ED-HMI3010-116C

PCN

by EDA Technology Co., Ltd

1 Product Change Notice 1

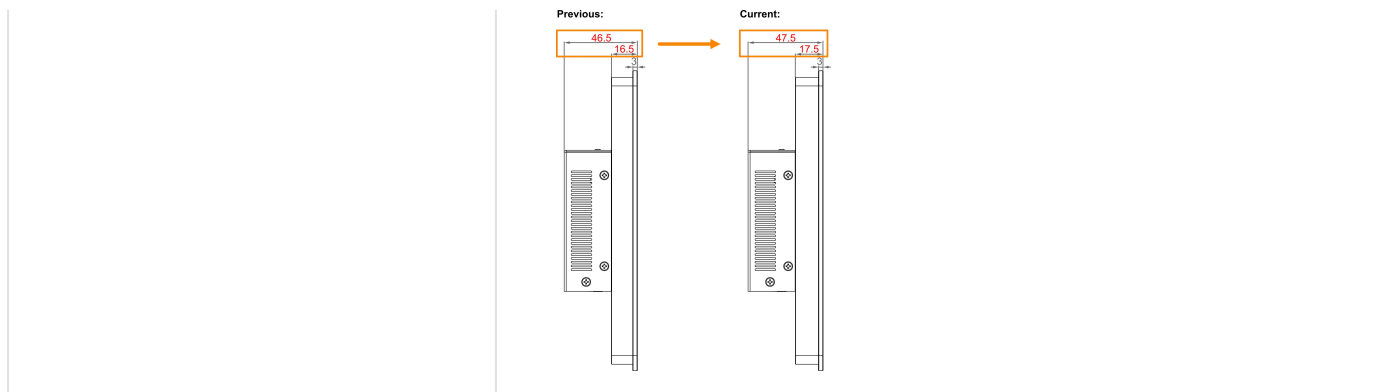
Product Structural Optimization

Changes	Results
LCD bezel thickness increased by 1mm	We have optimized the LCD bezel structure to provide additional clearance for internal cable routing. - LCD bezel thickness: adjusted from 16.5mm to 17.5mm. - Total product thickness: correspondingly adjusted from 46.5mm to 47.5mm.

It can be distinguished by measuring the product thickness.
